CERTIFICATE OF APPROPRIATENESS

Property: 1534 Cortlandt Street, Lot 21, Block 138, Houston Heights Subdivision. The property includes a historic 2,082 square foot, one-story wood frame single-family residence situated on a 6,600 square foot (50' x 132') interior lot.

Proposal: Alteration – Construct a covered, enclosed side porch.

NORTH SIDE ELEVATION

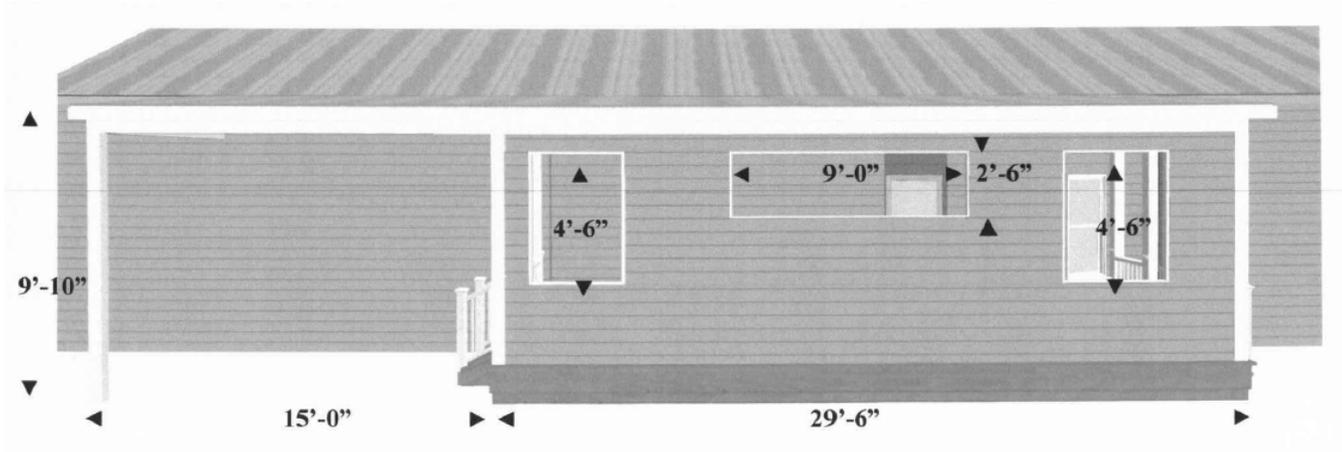
I SUPPORT the granting of a Certificate of Appropriateness for this application. The proposed side porch will not require the removal or change of any of the existing historic house material and all existing windows and doors will remain. I would suggest consideration be given to revising the proposed middle opening on the outside of the proposed porch to a vertical element opening rather than the proposed horizontal element opening. The openings simulate the appearance of windows, which in the HHEHD are historically vertical rather than horizontal. This would be a nicer design feature.
